**CITY OF ISSAQUAH
DEVELOPMENT SERVICES DEPARTMENT
DEVELOPMENT COMMISSION**

STAFF REPORT

File Nos.: Site Development Permit: PLN12-00066
 Shoreline Substantial Development Permit: PLN12-00065
 Administrative Adjustment of Standards: PLN12-00067

Project: Issaquah Plaza 221

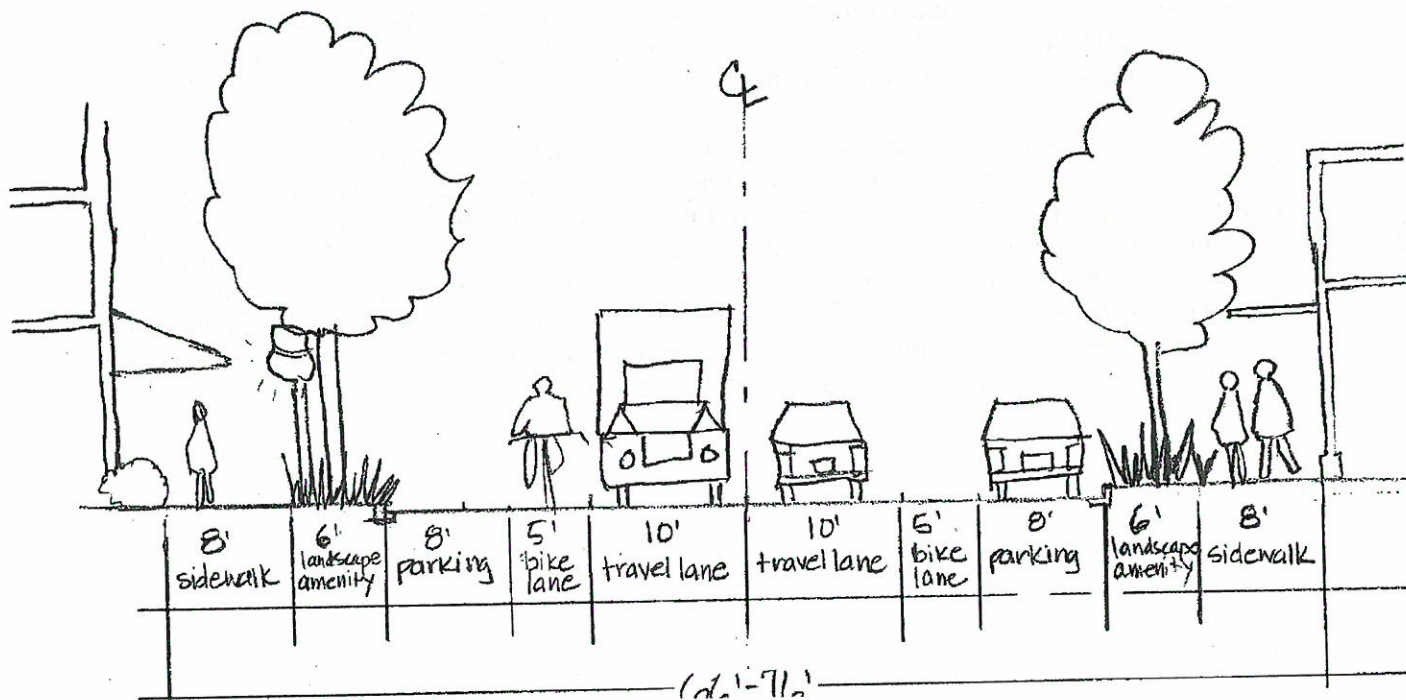
221st Street: The Map designates 221st as a Core Street. The street section is attached. The applicant will be required to provide half-street improvements of this section along their 221st frontage. The improvements consist of: 8' sidewalk; 6' planter strip; 8' parallel parking; 10' travel lane. Due to the nearby King County Regional Trail to the east and the close proximity of buildings and other site improvements further south on 221st the bike lane should not be included in this road section.

56th Street

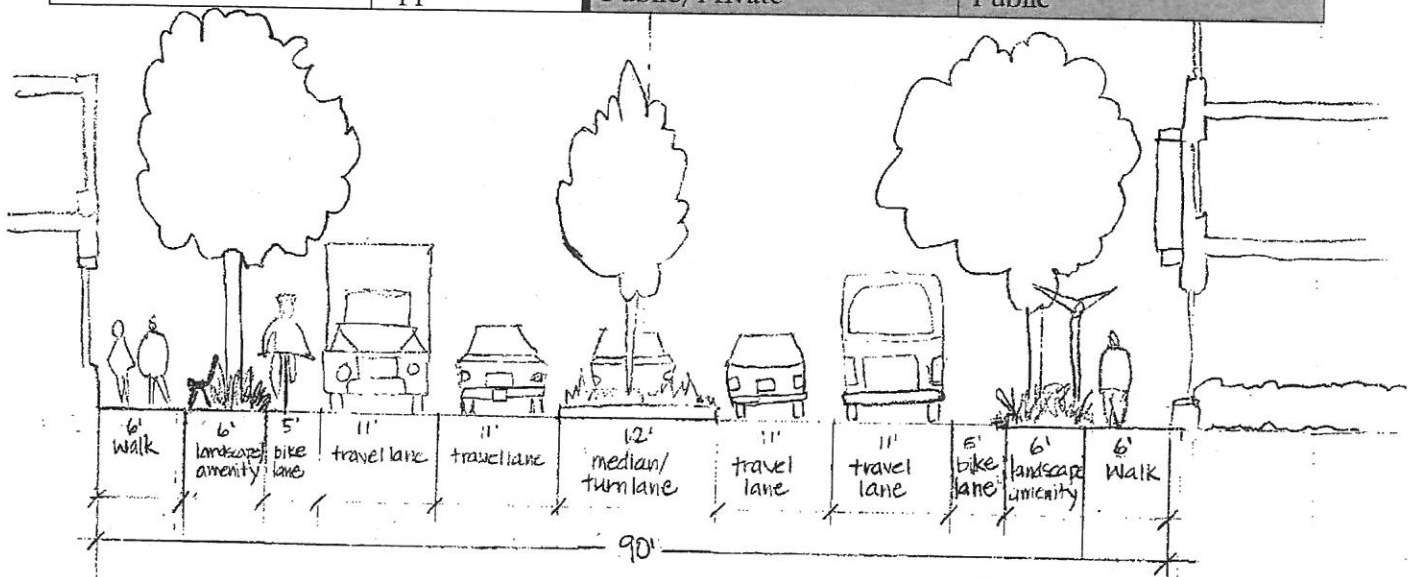
56th Street: The Map designates 56th Street as a Boulevard. The street section is attached. There are no plans at this time to improve this street. It is preferable to provide sufficient room for future expansion but not complete the improvements at this time so as to maintain a continuous 56th Street roadway. Section 6.2 provides the City with authority to require dedication of right-of-way or to reserve portions of the site for future right-of-way dedication. The section shows that 90 feet of right-of-way will be required to build the full section. City maps show there is approximately 103 feet of right-of-way, therefore dedication of right-of-way nor road improvements is not anticipated at this time.
